The TIPC has changed for the better:

Features of the NEW TIPC15 Touch Industrial Printer Controller

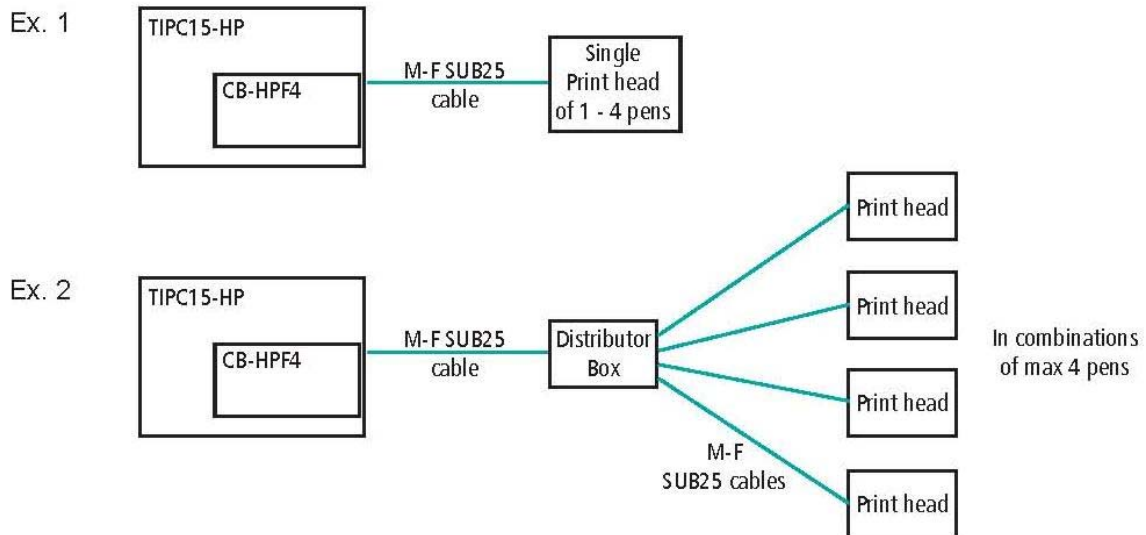
- NEW DESIGN - BLACK ANODIZED ALUMINUM FRAME
- TIPC15 FOR HP HAS THE NEW F-TYPE CONTROLLER BOARD CB-HPF4 BUILT-IN
- TIPC15 FOR HP WORKS WITH F-TYPE PRINT HEADS

The introduction over the past few months of the Fuse Type print head has reduced the number of pen stall failures that are common during incorrect handling of the print heads and cartridges. The fuse type of print head disconnects power as soon as the cartridge is removed from the pen stall, thus almost eliminating the need for costly drive board replacement.

The new design of the controller means that it is cheaper to use in the long run giving longer more operator friendly service.

Mounting Information

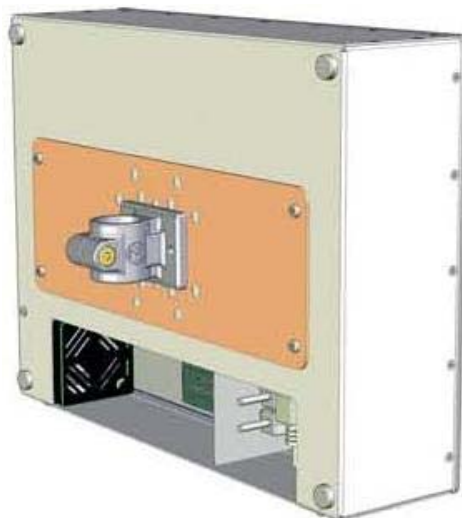
The TIPC15 comes with an adaptor plate with hole patterns to enable mounting in 2 positions.

Shown with Optional RFA-1000 Bracket
